AMENDMENTS TO THE DRAWINGS:

REMARKS

FIG. 1E
(Prior Art)

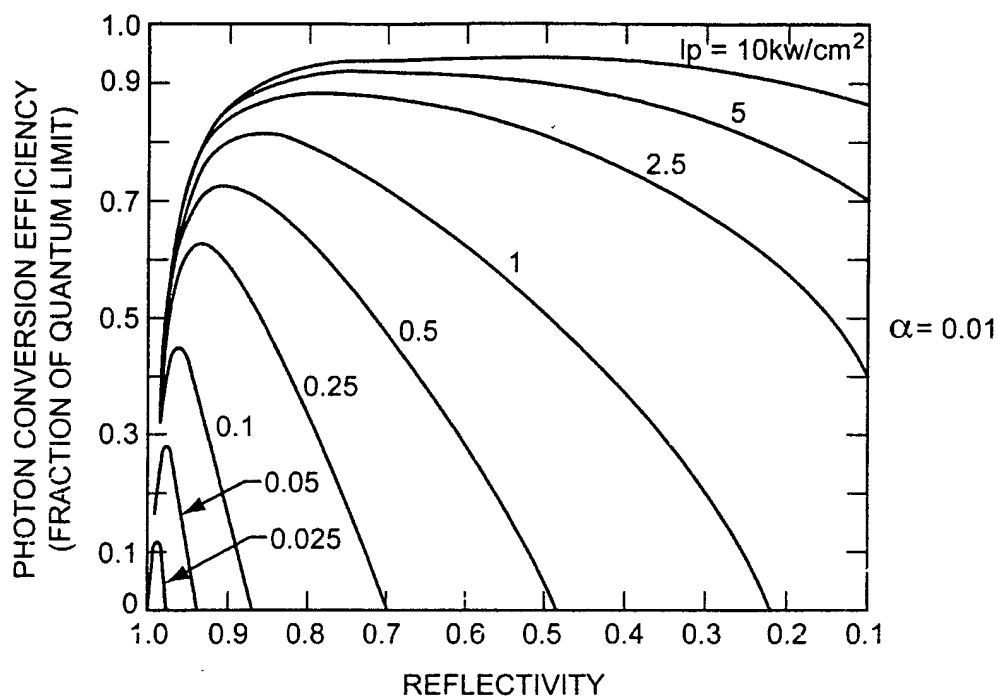
The attached sheets of drawings now include the legend “Prior Art” for Figures 1A-1F as requested by the Examiner on page 3 of the Office Action.

As suggested by the Examiner, Applicant has amended the drawings so that Figures 1A-1F are designated as “Prior Art.” Appropriate replacement sheets are attached to this response.
